UNITED STATES PATENT AND TRADEMARK OFFICE

10/582,736

Office Action Summary	Application No. 10/582,736	Applicant(s) UDO ET AL.	
	Examiner JENINE M. PAGAN	Art Unit 4147

DETAILED ACTION

Parkhurst et al. (US 5,412,372)

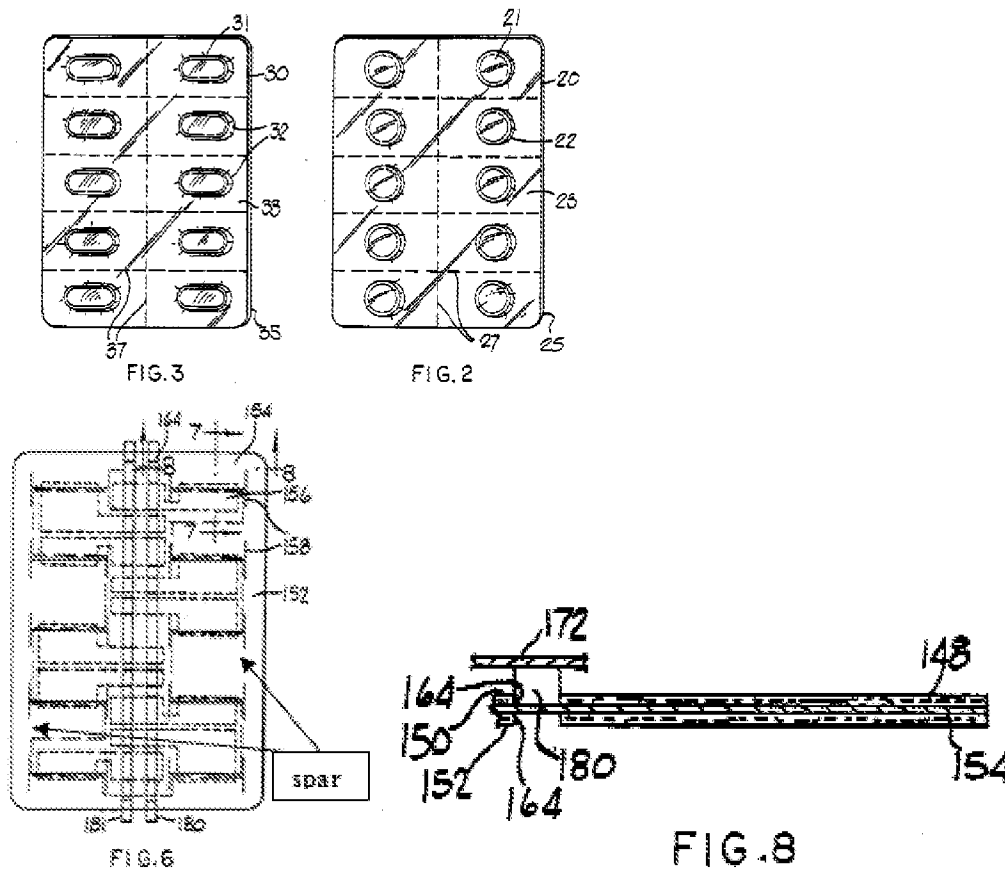
5. In re claim 1, with reference to Figure 2,3,6 and 8, Parkhurst '372 discloses:

- a blister package (20,30) and a conductor carrier strip (154) connected to it, wherein openings (164) in the conductor carrier strip (154) are directed toward pockets (22,32) of the blister package (20), and wherein, upon removal of a tablet (21) from a pocket (22,32), a sealing film (150) of the blister package (20) sealing the pocket (22,32) must be separated, and the tablet (21) is removable through an opening (164) assigned to it, the improvement wherein the openings (164) are formed by stamped lines (158)

positioned within the conductor carrier strip (154) that surround each of the pockets (22,32) in a ring shape, and that are interrupted by at least two spars (See Figure 6 above) by means of which a covering (148), separated by the stamped line (158) out of the conductor carrier strip (154) and covering (148) the pocket (22,32), is connected with the conductor carrier strip (154); wherein the spars (See Figure 6 above) are so distributed about the periphery of the stamped line (158) that, when a tablet (21) is pressed out from a pocket (22,32), at least one spar (See Figure 6 above) is severed; and wherein the conductor carrier strip (154) includes individual conductors (156) each of which extends from an individual connecting pad (180) over at least the one spar (See Figure 6 above) that is severed upon tablet (21) removal.

- the spars (See Figure 6 above) are positioned diametrically opposite each other about the circumference of the stamped line (158), and wherein the individual conductor (156) associated therewith extends over both spars (See Figure 6 above)

10. In re claim 6, with reference to Figure 2,3,6 and 8, Parkhurst '372 discloses:
- the two spars (See Figure 6 above) each lie along the direction of the longer extension of the stamped line (158)

11. In re claim 7, with reference to Figure 2,3,6 and 8, Parkhurst '372 discloses:
- the individual conductor (156) extends over the first and the additional spars (See Figure 6 above)

12. In re claim 8, with reference to Figure 2,3,6 and 8, Parkhurst '372 discloses:
- the individual conductor (156) extends only over one of the spars (See Figure 6 above) from the conductor carrier strip (154) to the covering (148), and from the covering (148) back to the conductor carrier strip (154) as a loop, whereby the conductor-bearing spar (See Figure 6 above) is positively severed upon tablet (21) removal
